FINAL APPELLANT COMMENTS

FORMATION OF VEHICULAR FARM ACCESS AND ASSOCIATED TRACK (PART RETROSPECTIVE) NEWLANDS FARM NEWLANDS ROAD CLOUGHTON

Appeal ref: APP/W9500/W/21/3272597

North Yorkshire County Council Highways & Transportation Department	CONCRETE FARM CROSSING RURAL INDUSTRIAL ACCESS	DATE	DRAWING NO.	Rev.
		1/6/95	E2

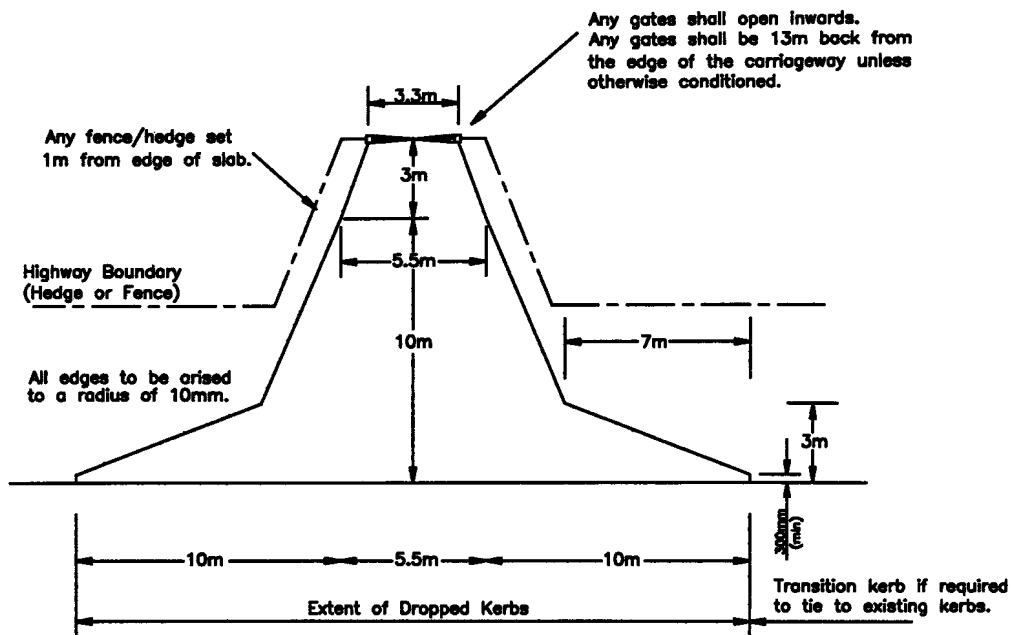
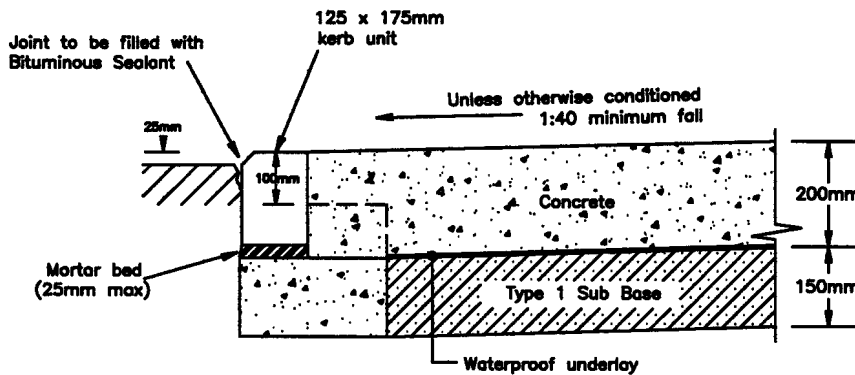
Condition 3 – The Standard Detail E30 is for ‘Quarries and Major Industrial Estate Roads’ and is a totally inappropriate specification for a farm access. The attached E2 standard detail is more appropriate and from the same NYCC source document. Beyond the extents of the standard detail the access into the site certainly does not need to be constructed in accordance with ‘Specification for Housing and Industrial Estate Roads and Private Street Works’. Suggest that it is made clear that any condition relates to the bell mouth of the access where it meets the highway.
